# Access Compliance Report

## Public Rights-of-Way

### (Curb Ramps)

Intersection ID: N/A	Main Street: INVERNESS_BAY_RD	Cross Street: PERTH_MOOR_RD	Location: NW
ADA ID: 076F33637515	Ramp Type: Perp	Initial Pass/Fail: Fail	Overall Compliance: No
Severity Score: 21.25			
Codes/Mitigation Info/Possible Solution		Field Measurements/Component Compliance

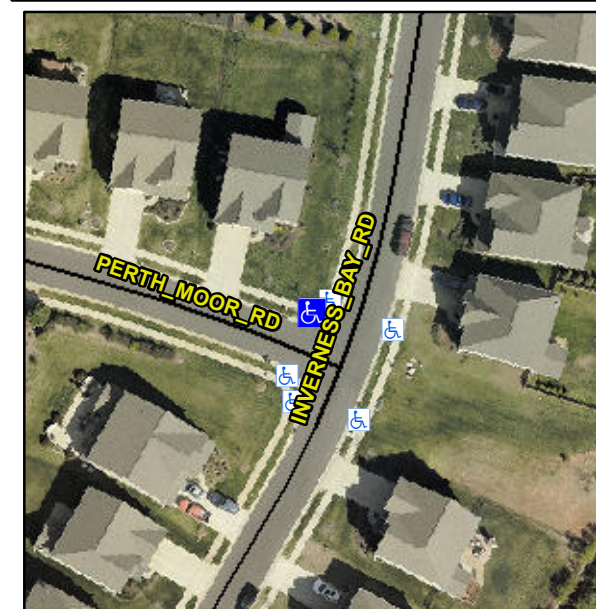
**R304.5.1, R304.2.2**

Compliance	Description	Data	Compliance	Description	Data
N/A	Ramp Length (in)	48.0	No	Ramp Slope (%)	11.6
No	Ramp Width (in)	41.0	Yes	Ramp XSlope (%)	1.2
N/A	Flare Type LT	N/A	N/A	Flare Type RT	N/A
N/A	Flare Slope LT (%)	N/A	N/A	Flare Slope RT (%)	N/A
N/A	Flare Traversable LT?	N/A	N/A	Flare Traversable RT?	N/A
N/A	Landing Length (in)	N/A	N/A	DWS Provided?	N/A
N/A	Landing Width (in)	N/A	N/A	DWS Contrast?	N/A
N/A	Landing Slope (%)	N/A	N/A	DWS Length (in)	N/A
N/A	Landing X Slope (%)	N/A	N/A	DWS Full Width?	N/A
N/A	Landing Curb? (Y/N)	N/A	N/A	DWS Offset (in)	N/A
N/A	Shared Landing?	N/A			
N/A	Gutter Ponding?	N/A	N/A	Gutter Slope (%)	N/A
N/A	Gutter Lip Ht (in)	1.5	N/A	Gutter X Slope (%)	N/A
N/A	Painted X Walk1?	No	N/A	Painted X Walk2?	N/A
	X Walk 1 Direction	To SW		X Walk 2 Direction	N/A
N/A	X Walk 1 Width (in)	N/A	N/A	X Walk 2 Width (in)	N/A
	X Walk 1 Slope (%)	1.6		X Walk 2 Slope (%)	N/A
	X Walk 1 X Slope (%)	1.1		X Walk 2 X Slope (%)	N/A

**Remove & Replace Entire Ramp.**
